**GIRDWOOD VALLEY SERVICE AREA BOARD OF SUPERVISORS**

January 14, 2019

The Girdwood Board of Supervisors (GBOS) is the elected body which represents the Community of Girdwood, Alaska. We are writing to express our community's desire to identify solutions to recurring issues along Alyeska Highway.

**DIAGRAM 1-1**

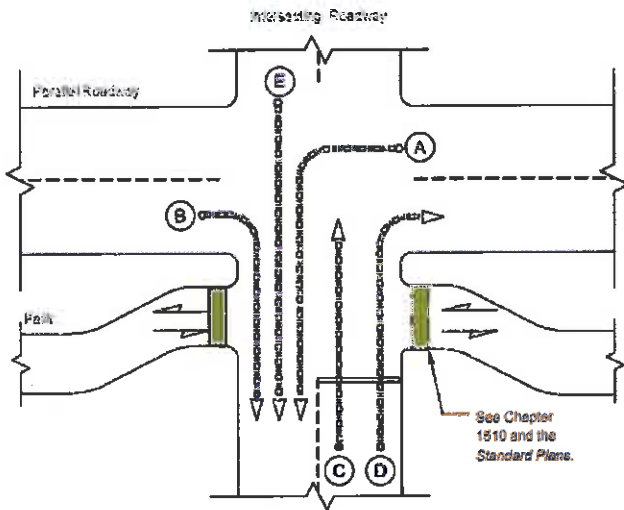
Girdwood seeks a design that keeps our community and visitors safe. The current design places path users in potential conflicts, specifically pedestrians and motor vehicle traffic on Alyeska Highway and the path itself, as shown in Diagram 1-1<sup>4</sup>.

In Diagram 1-1, the path user faces potential conflicts with motor vehicles turning left (A) and right (B) from the parallel roadway and on the crossed roadway (C, D, and E). So that motorists and path users recognize one another, the crossing path should be moved. An important design element to consider for traffic right of way is the separation distance between path and roadway. Figure 1-1 measures the safe distances among the roadway shoulder and the paved Shared-Use Path in areas with greater to or equal 35 mph<sup>5</sup>.
